**Remarks**

**Claims 1-9 are currently pending in the application.**

FIG. 5

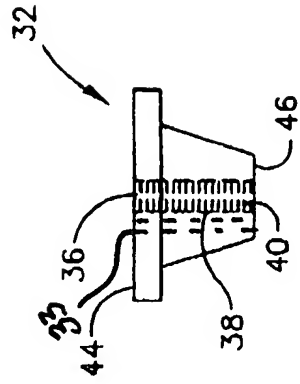
**In Figure 5 insert the numeral 33 indicating an aperture in valve stop 32;**

FIG. 6

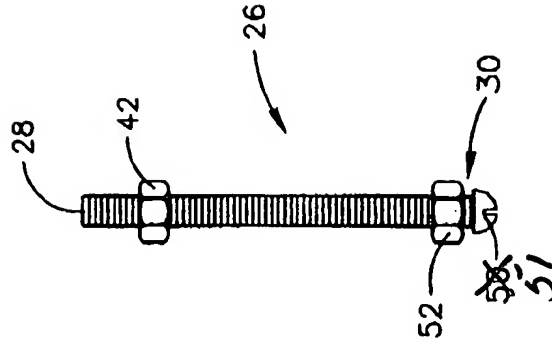
**The drawings stand objected to in that: 1) the reference character “50” has been used to designate two elements of the apparatus; and 2) the reference numeral “51” while mentioned in the specification is not shown on the drawings. The numeral “50” has been deleted from Figure 6 and the numeral “51” substituted therefore to eliminate this confusion.**

**In Figure 6, delete “50” and substitute therefore - - 51 - -;**
